POLK COUNTY

NOTICE OF PLANNING COMMISSION DECISION

OWNER: David Knieling Trust and Rebecca Knieling Trust
APPLICANT: Haley Knieling-Norwood
FILE NUMBER: LUD 22-79
SUBJECT PROPERTY: 6565 Spring Valley Road NW, Salem, Oregon 97304 (T6S, R4W, Section 25, Tax Lot 200)
REVIEW AND DECISION CRITERIA: Polk County Zoning Ordinance (PCZO) Section 183.050(A) and (B).
STAFF CONTACT: Eric Knudson; Phone: (503) 623-9237;
Email: knudson.eric@co.polk.or.us

**Polk County Community Development Department
Planning Division Staff Report**

Figure 1: Existing windows on the east elevation (front) of the Phillips House.

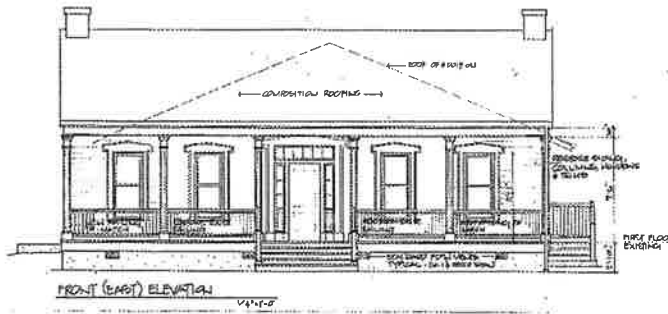
Based on the photographs and plans provided by the applicant, the existing windows on the east elevation (front) are composed of a single large pane of glass (see Figure 1). However, the National Register suggests that this was not original but existed at the time the property was included in the Register. The proposed windows would be matching double-hung Marvin wood windows (see Figure 2).

Figure 16: Existing north facing side of the Phillips House and addition.

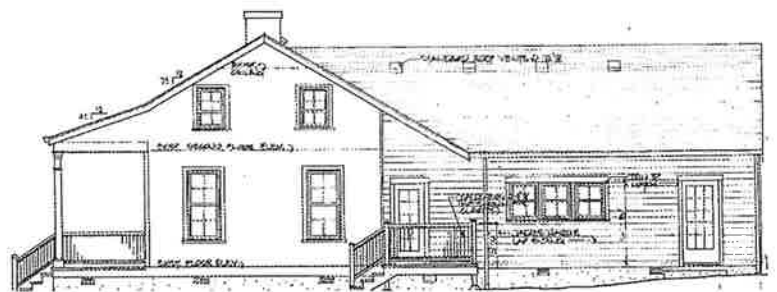
The north side of the primary dwelling has approximately 70.7 square feet of fenestrations and approximately 329.1 square feet of solid space (see Figure 16). The north side of the primary dwelling contains approximately 21.5% of its total area as fenestrations.

The north facing side of the proposed addition has approximately 62 square feet of fenestrations and approximately 253 square feet of solid space. (see Figure 17). The north side of the proposed addition would contain approximately 19.6% of its total area as fenestrations.

Figure 18: Existing south facing side of the Phillips House.

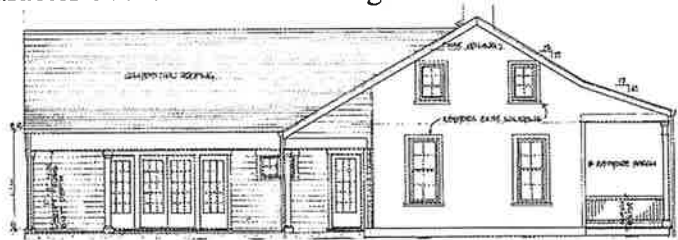
The south facing side of the primary dwelling has approximately 71.5 square feet of fenestrations and approximately 335.1 square feet of solid space (see Figure 18). The south side of the primary dwelling contains approximately 21.3% of its total area as fenestrations.

As seen in Figure 18 above, the existing portion of the primary dwelling that is still exposed appears to contain one single leaf door and shows no resemblance or character of the Classical Revival architecture design that can be found on the rest of the primary dwelling. For this reason, staff finds that as proposed, the French doors would be visually compatible and harmonious to that of the Phillips House and would not detract from the overall appearance and character of the historic building, so long as they are made using the same materials as those found on the other fenestrations of the dwelling.
